ADDENDUM NO. 03

June 21, 2024

Additions and Renovations to Franklin Central High School Phase 2B
6215 S. Franklin Rd.
Indianapolis, IN, 46259

4 AHU-K1 DETAIL
NOT TO SCALE

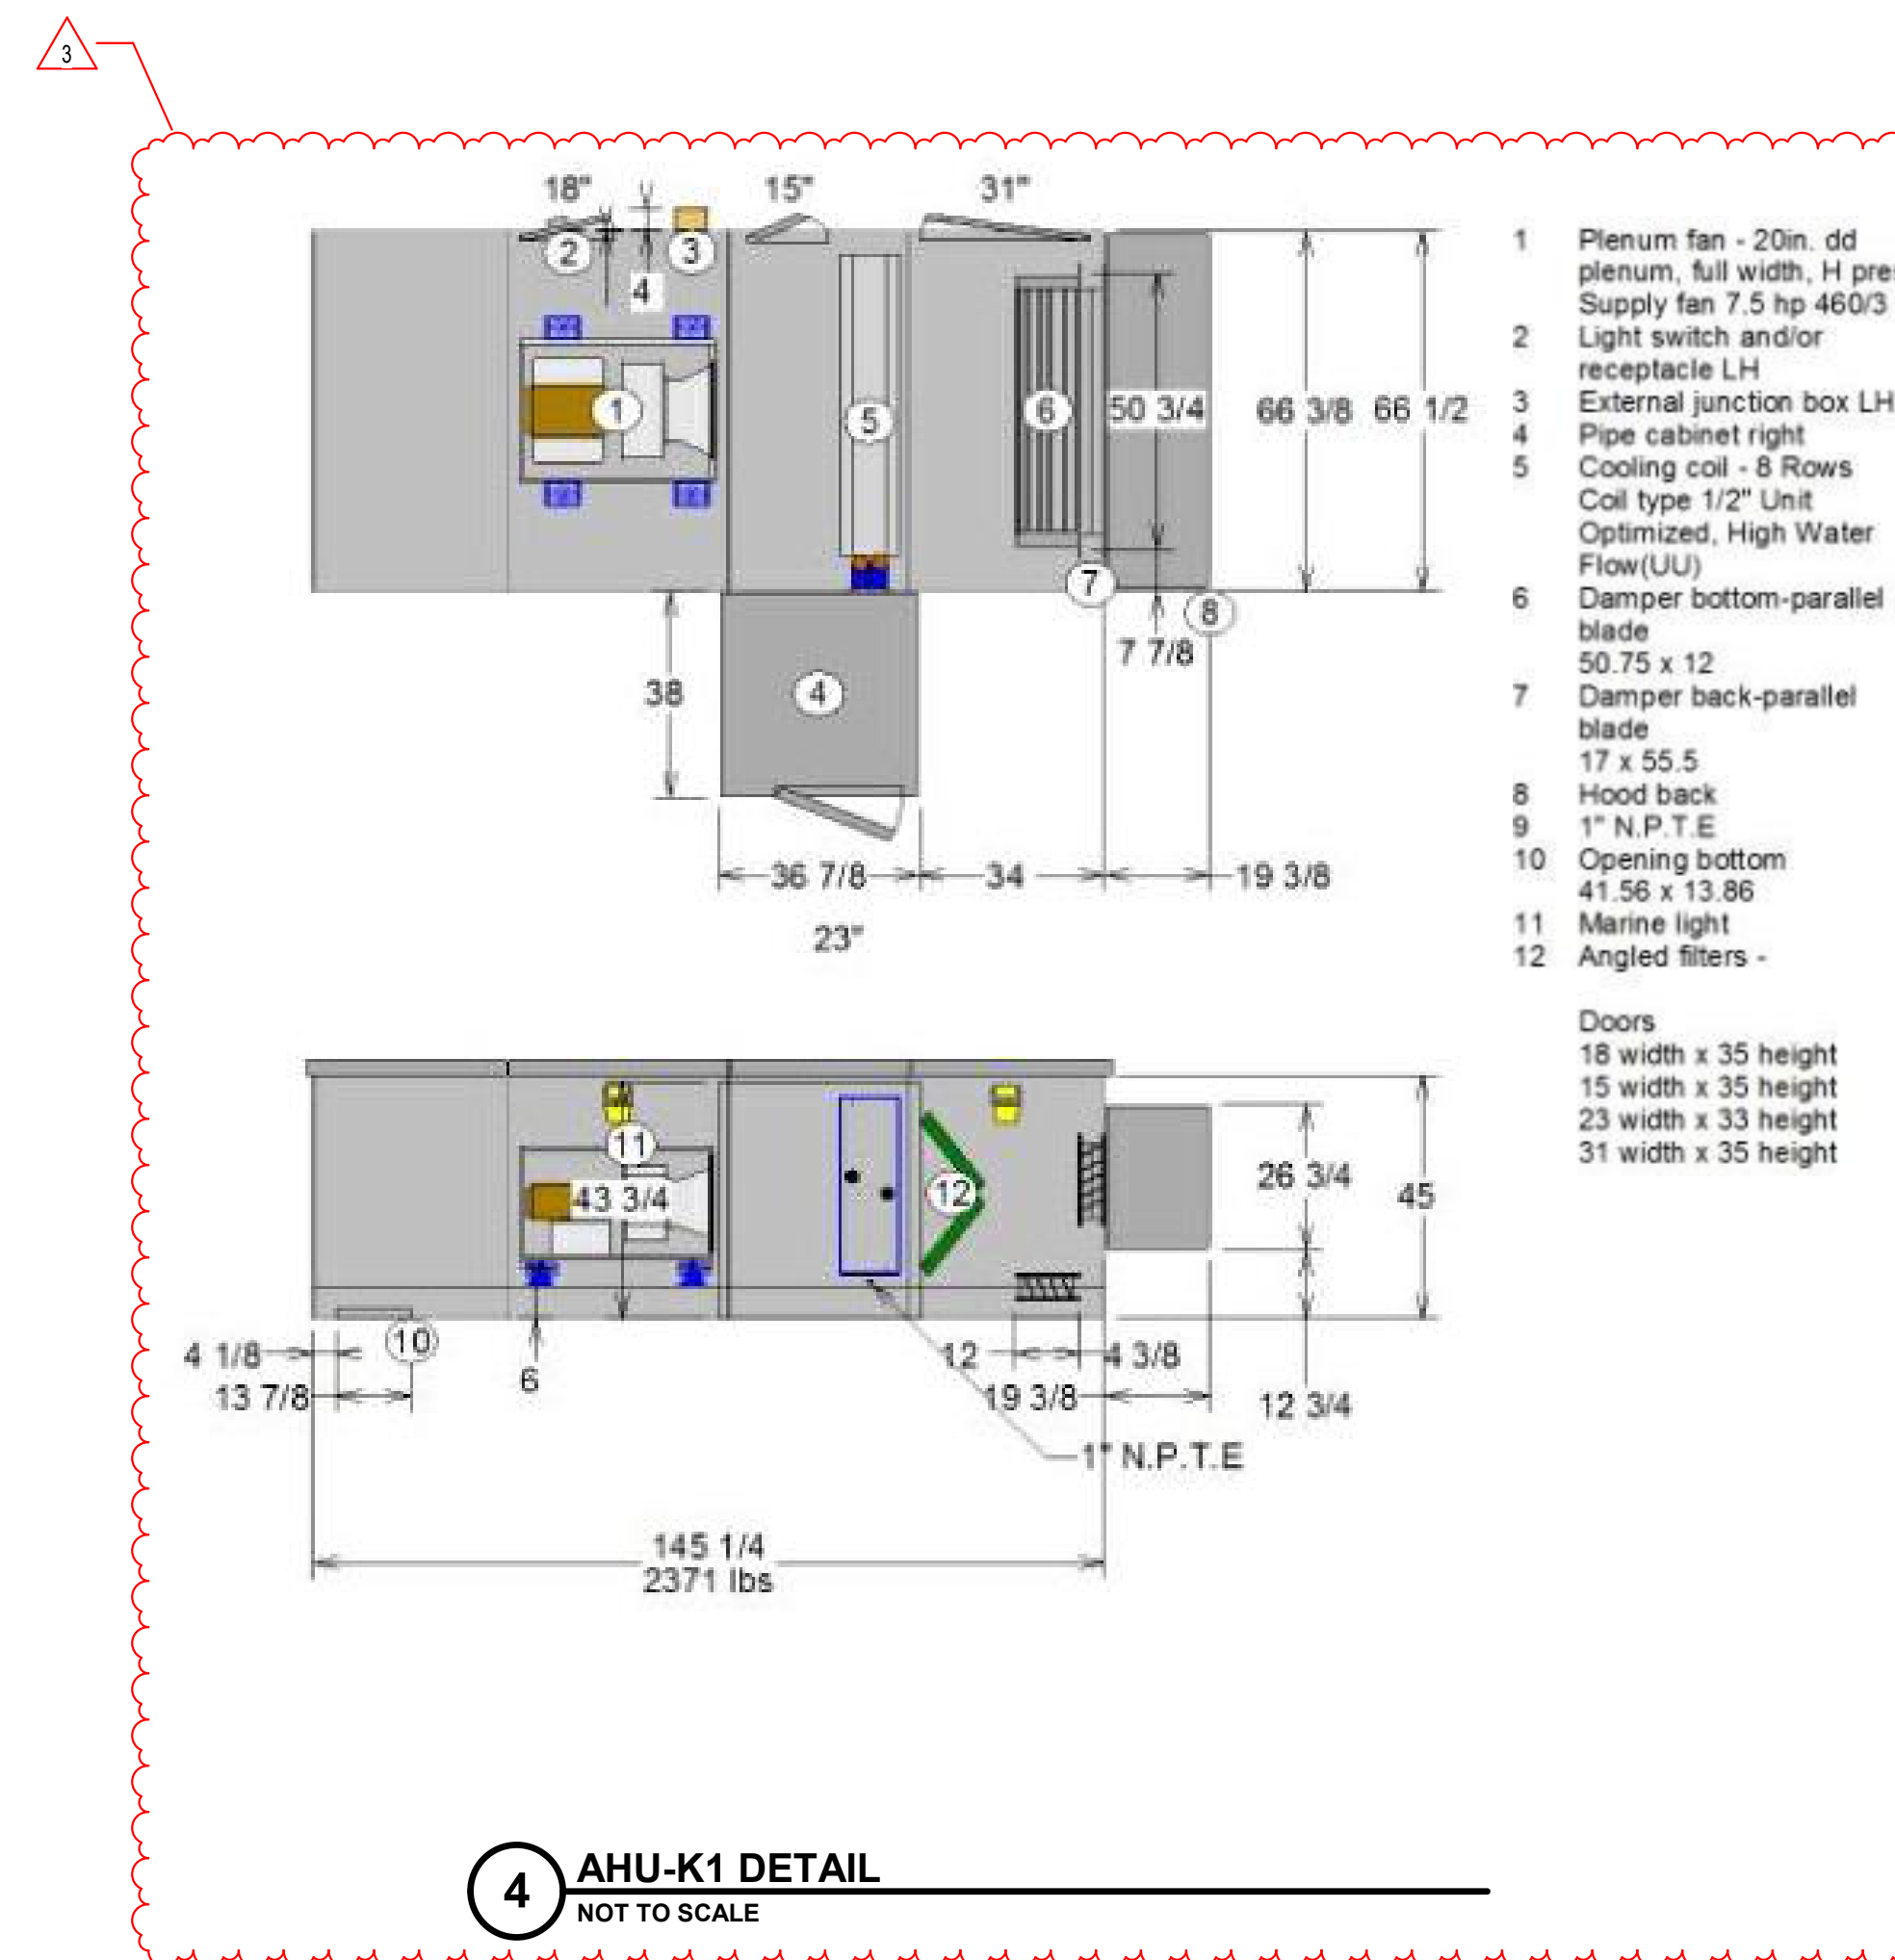
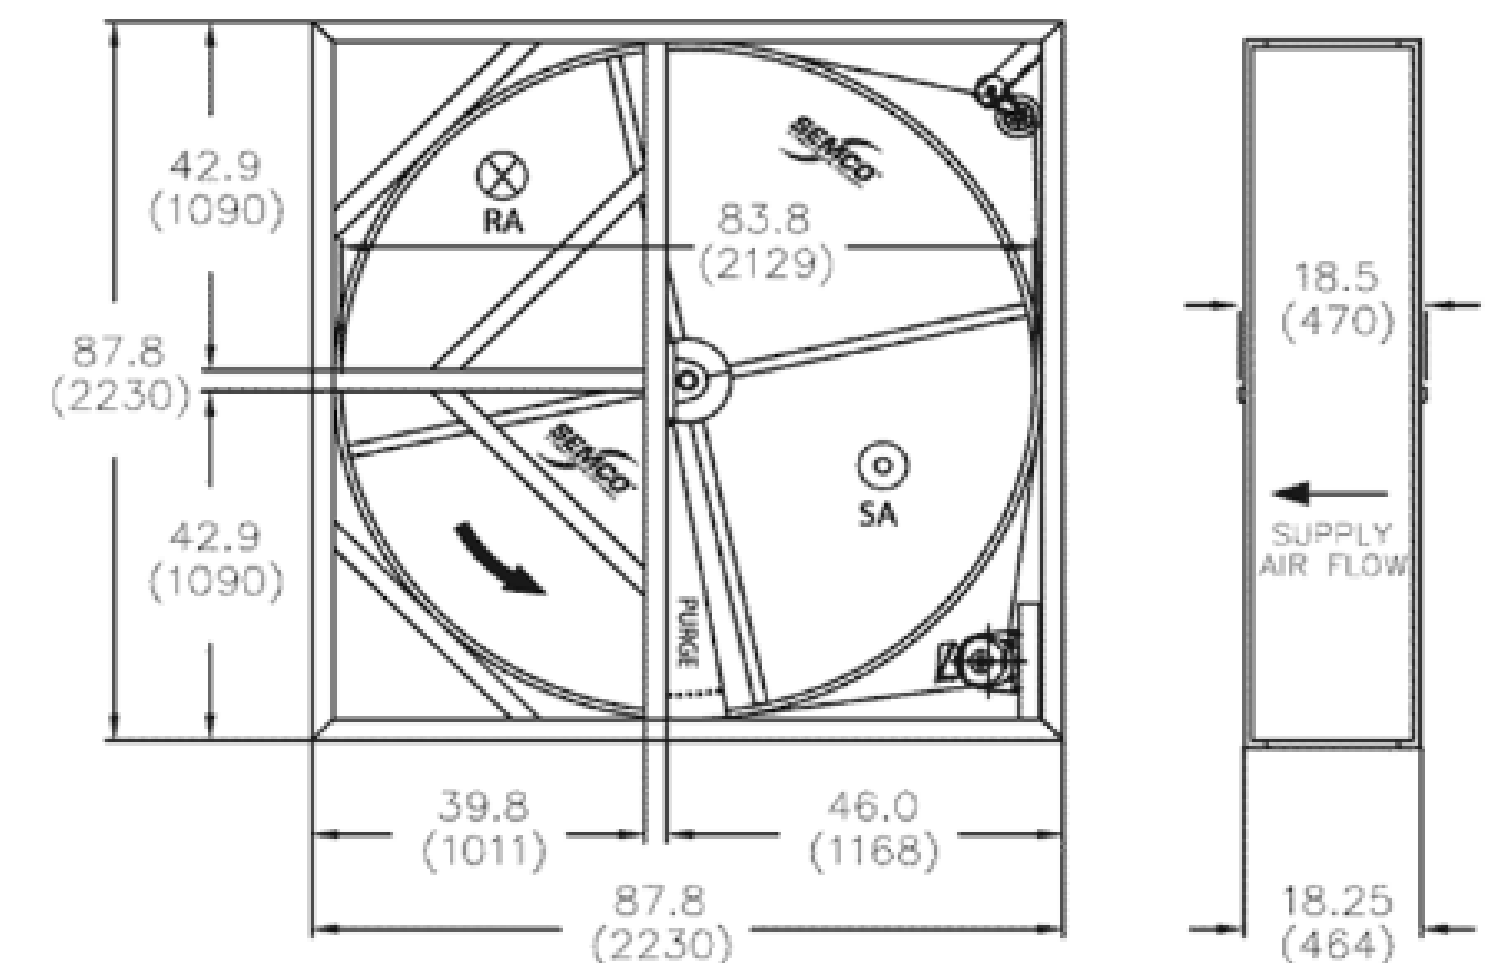
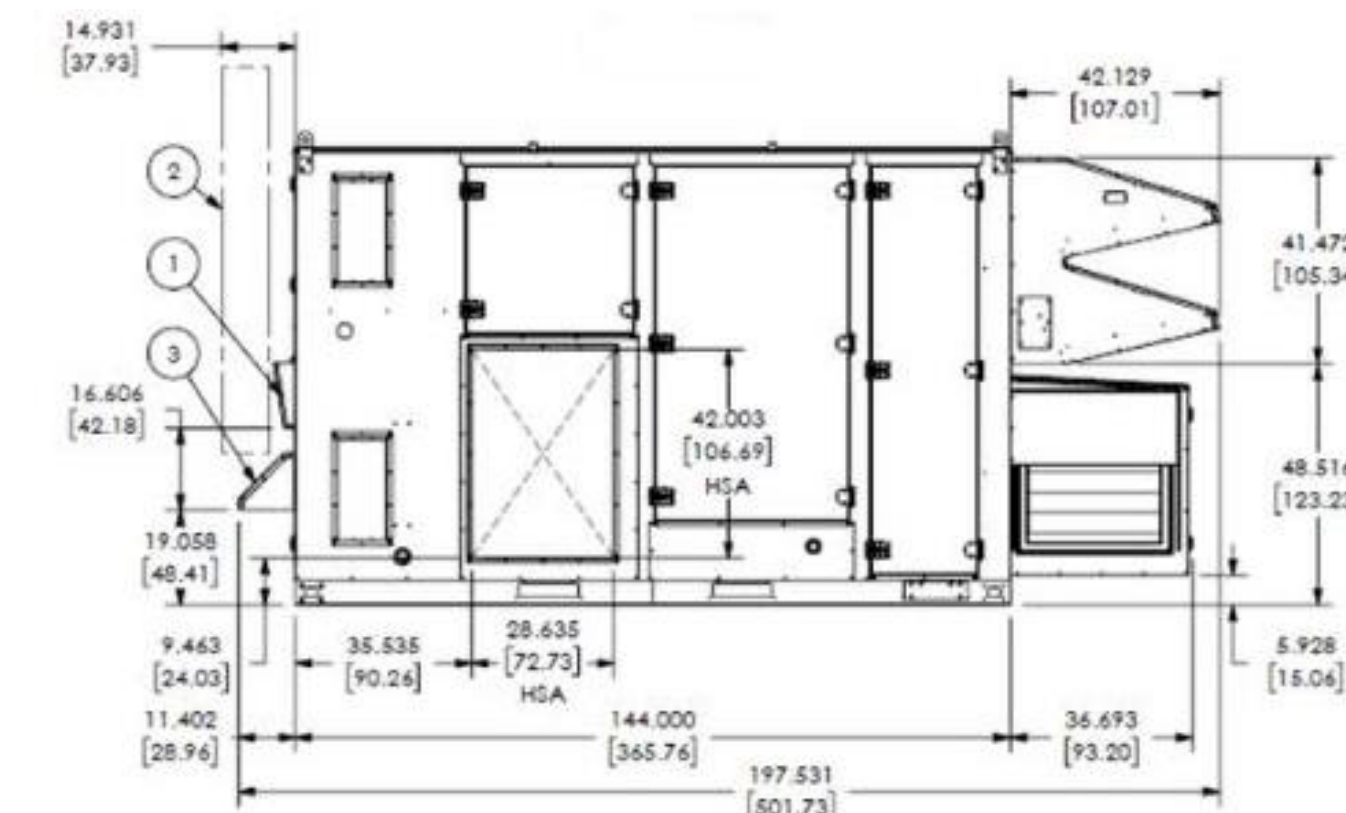
3-19 Section 237313.13 Indoor Basic Air-Handling Units: Revise Paragraph K.2 as follows:

1. DELETE AND REPLACE Paragraph K.2 in its entirety and replace with the following:

- a. Fabrication: Formed and reinforced, double-wall and insulated panels of same materials and thicknesses as casing.
- b. Hinges: A minimum of two ball-bearing hinges or stainless steel piano hinge and two wedge-lever latches, operable from inside and outside. Arrange doors as shown on details on drawings. Provide safety latch retainers on doors so that doors do not open uncontrollably.
- c. Gasket: Neoprene, applied around entire perimeters of panel frames.
- d. Size: Large enough to allow for unobstructed access for inspection and maintenance of air-handling unit's internal components. At least 12 inches wide by full height of unit casing up to a maximum of 60 inches"
